ADDENDUM NO. 2

BID NO. 2838

**CLOVIS EAST HIGH SCHOOL CTE FARM AND FOOD PRODUCT FACILITY
CLOVIS UNIFIED SCHOOL DISTRICT
CLOVIS, CALIFORNIA**

G.A. PROJECT NO. 1739

1 DETAIL
SCALE: 1"=1'-0"

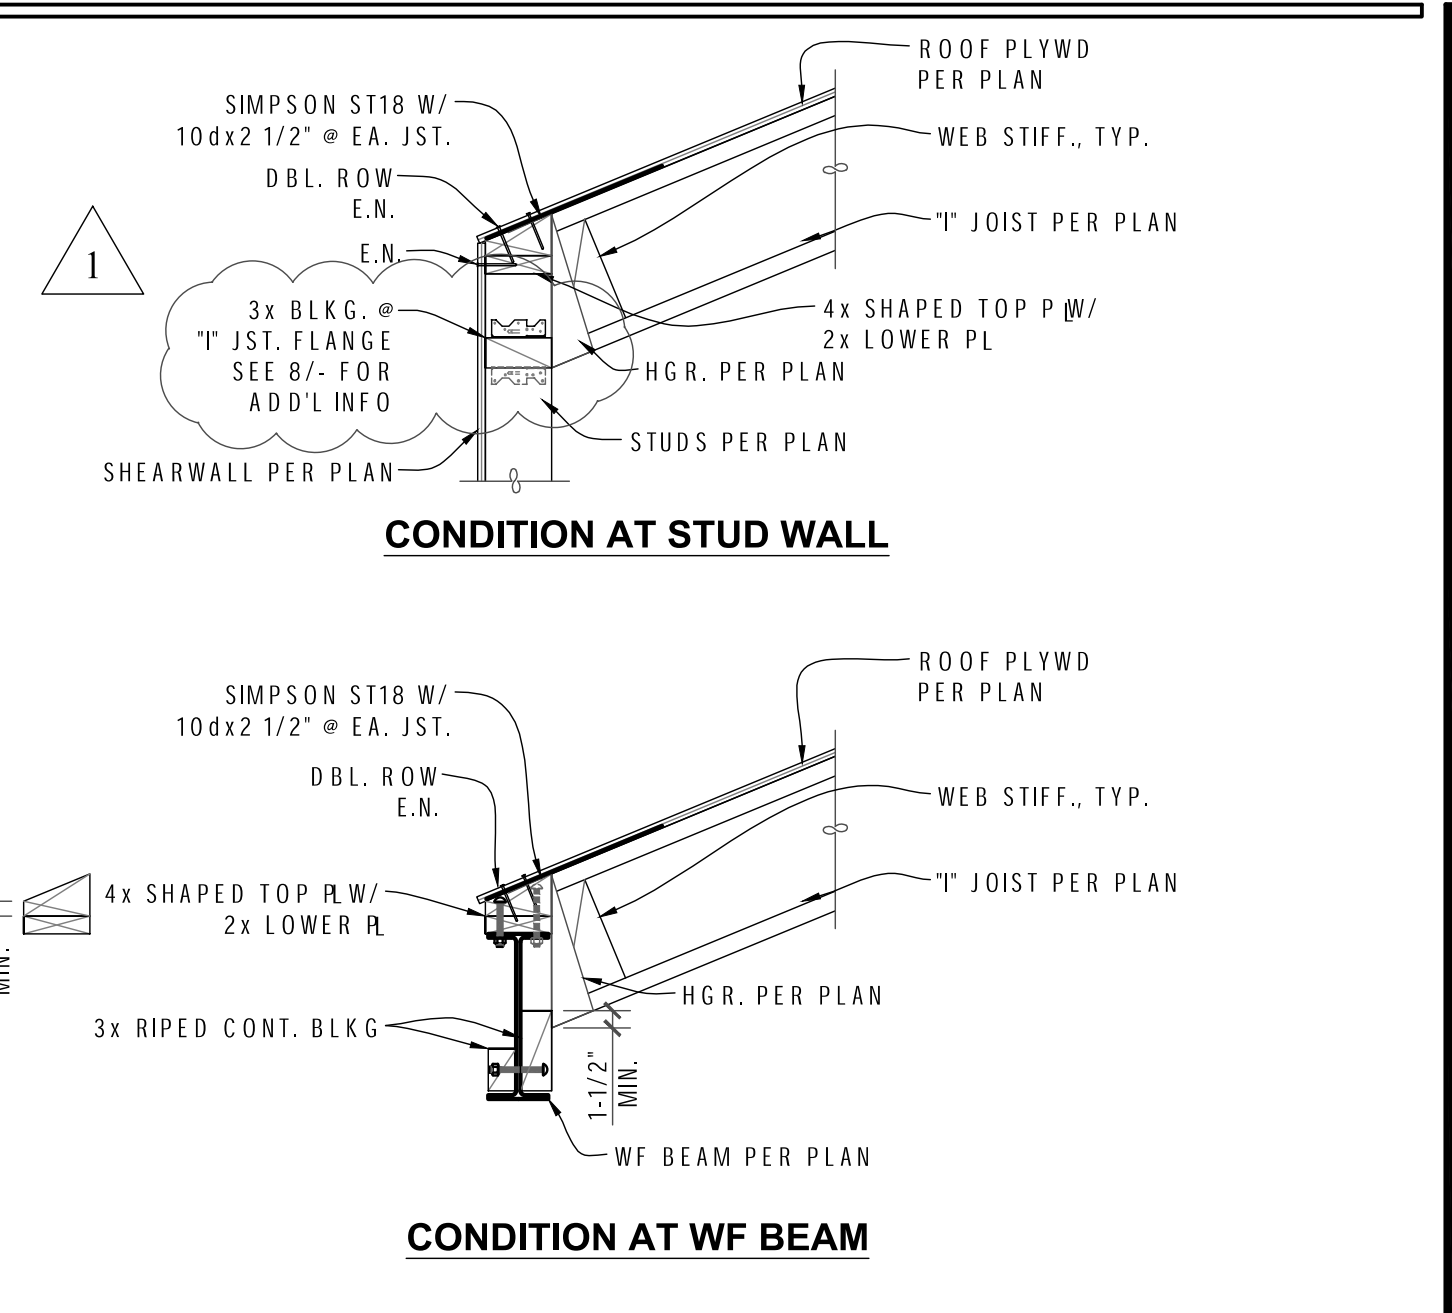
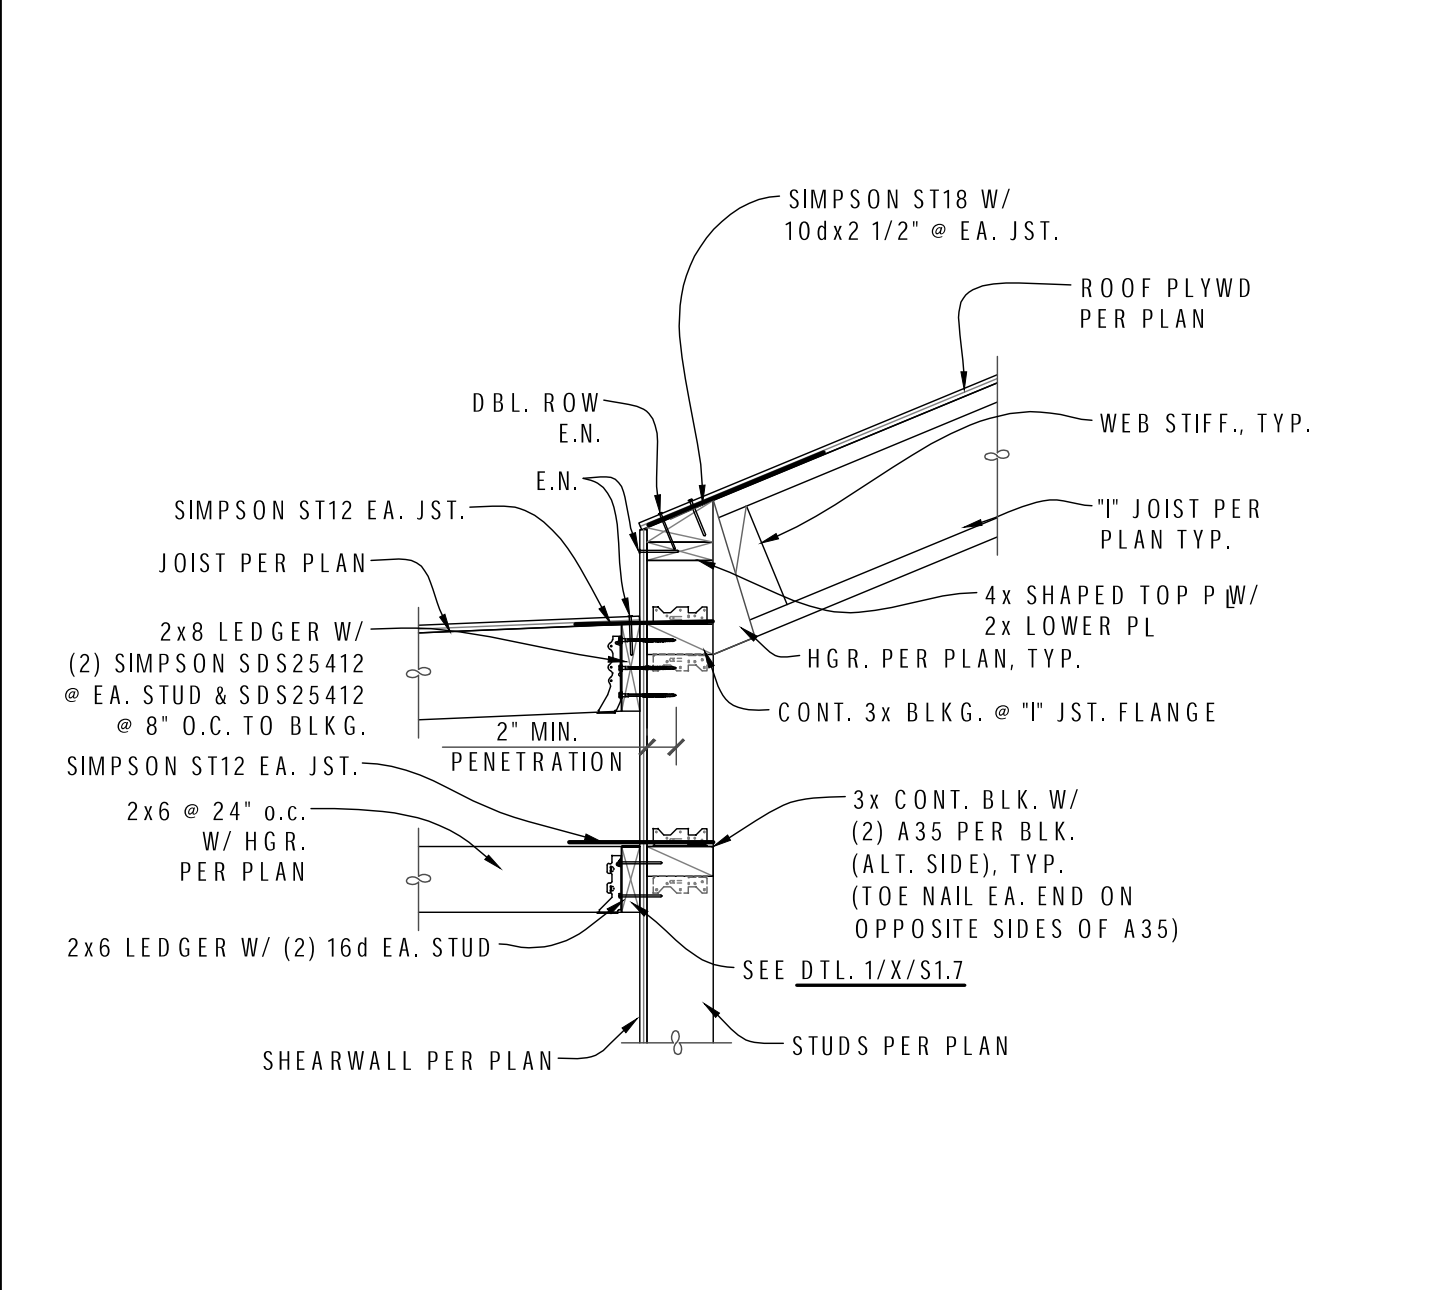
S6.1:

- 1.) Clarified and provided required 3X blocking.
- 2.) Clarified full depth blocking.
- 3.) Revised and clarified tie straps.
- 4.) Revised and clarified ledger Information and quantity of fasteners required.
- 5.) Provided additional blocking and nailing on detail 5.
- 6.) Provided cover sheathing @ parapet on detail 7.
- 7.) Revised and clarified detail 11.
